SR-2 – ADVISORY STAFF REPORT (03-06-2026)

ADDRESS: 14539 GLASTONBURY

APPLICATION NUMBER: HDC2026-00040

SCOPE: REPLACE FRONT PORCH

14539 Glastonbury. Staff photo taken in 2002

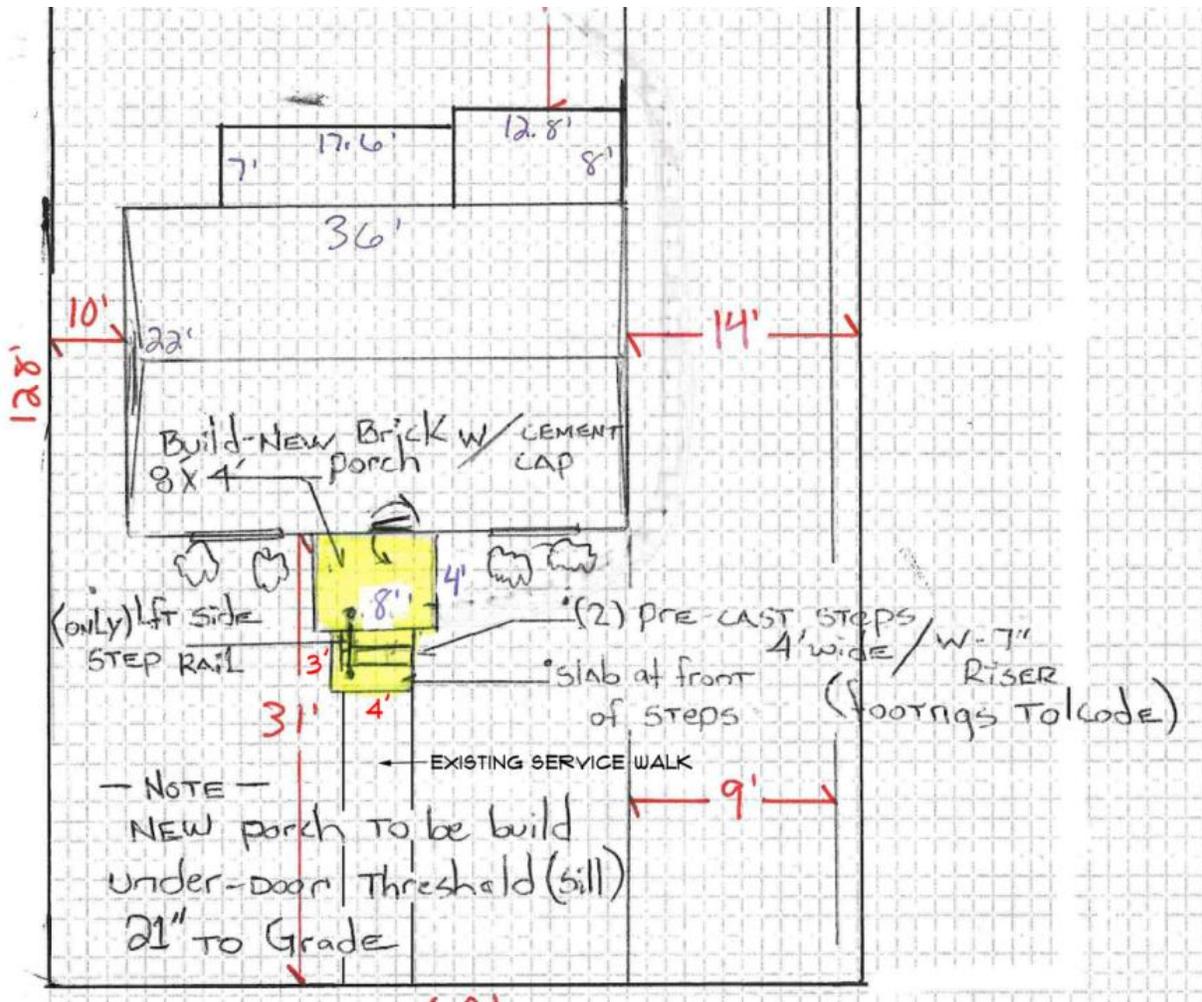
- The Rosedale Park historic district was designated in 2007. The above photo of the property, taken in 2002, indicates that the current front façade porch was present at the time of the district’s designation (see yellow arrow)
- A review of the design and materials of the current front porch indicate that it was installed well after the district’s period of significance, likely in the 1990s (see below photo)

Elevation drawing of the proposed new porch

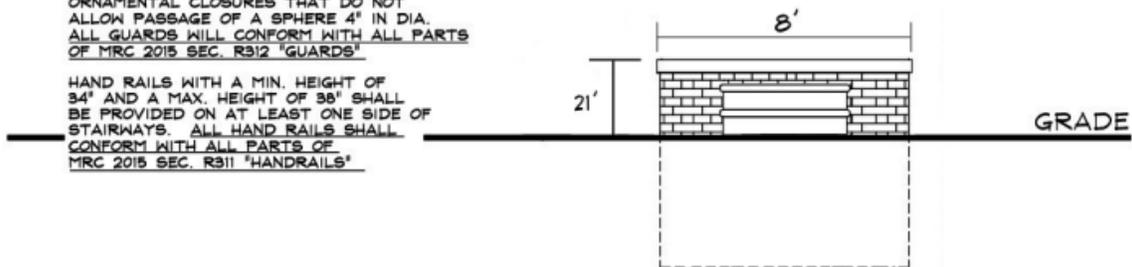
- It is staff’s opinion that the current porch detracts from the house’s historic character and is not an historic distinctive character-defining feature of the house as it was installed after the district’s period of significance.
- The proposed new porch will be constructed of salvaged brick and will have a concrete floor/cap and concrete steps. The porch will also measure 4’-0” in depth and will be 8’0” wide. A single 36”-high, aluminum handrail shall be installed at the south end of the new porch. In email correspondence sent to HDC staff on 3/3/2026, the applicant stated that the new porch will be centrally located on the building’s façade/in front of the main entry despite the below plan, which appears to indicate that it will be slightly offset to the south of the front door.

Elevation drawing of the proposed new porch

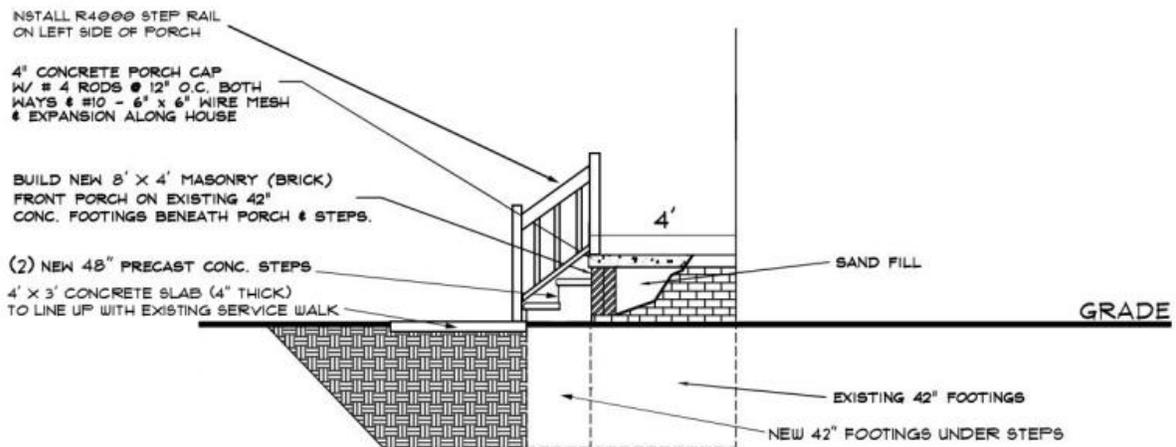
- It is staff's opinion that new porch design is compatible with the house's historic character and conforms to the district's Elements of Design
